Table of Contents

Key Findings by the Citizens Committee

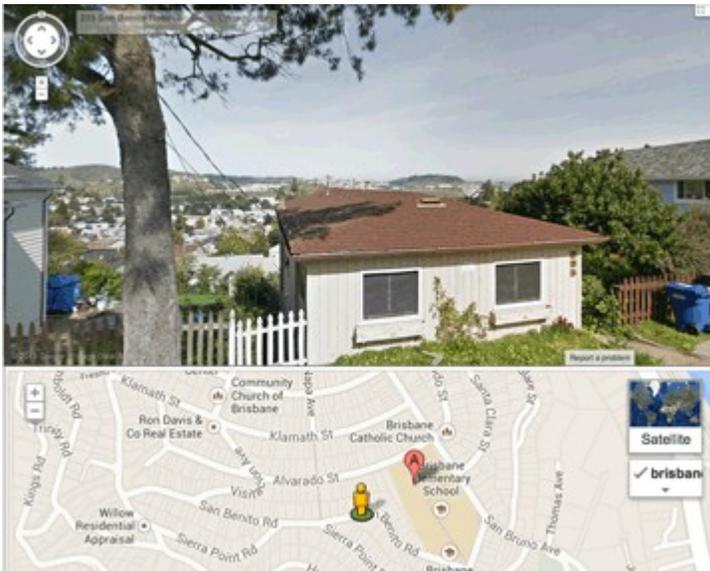
<p>Tunnel Ave & Beatty Ave.</p>	
<p>Beatty Ave.</p>	
<p>General</p>	<p>Brisbane has held a major public workshop entitled “Place Making,” in which concepts of focusing on collective vision and inspiration of “destination” were discussed. In order to forestall more urban sprawl at our front door, new Place Making public workshops specific to the Project are necessary.</p> <p>Reference: City of Brisbane’s web page http://www.brisbaneca.org/community-visioning-workshops</p>
<p>General</p>	<p>A view-enhancing concept that should be included is the exterior design of buildings with living roof structures as in the photos below.</p>

These roofs could be planted with native species, particularly geared to creating habitat for rare and endangered species.

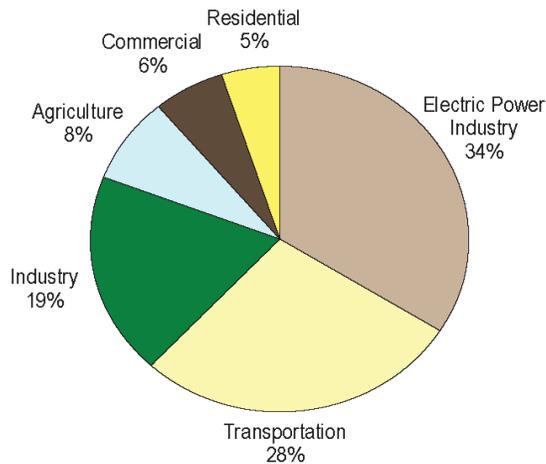
4.F-4	<p><i>“of the sources in this total, the largest contributors include transportation sources, industrial energy, and solid waste disposal...”</i></p> <ol style="list-style-type: none">1. This economic sector-based view limits the tools available to Brisbane to mitigate the Greenhouse gas emissions from the project.2. A systems-based view uses the same data used in the sector-based analysis, but, this view provides the greenhouse gas emissions used to manufacture and transports goods and food.3. When a city uses a system-based inventory, in addition to a sector-based inventory, more remedies are available to them including source reduction, zero waste policies, design for deconstruction, product stewardship policies and programs, and green procurement.
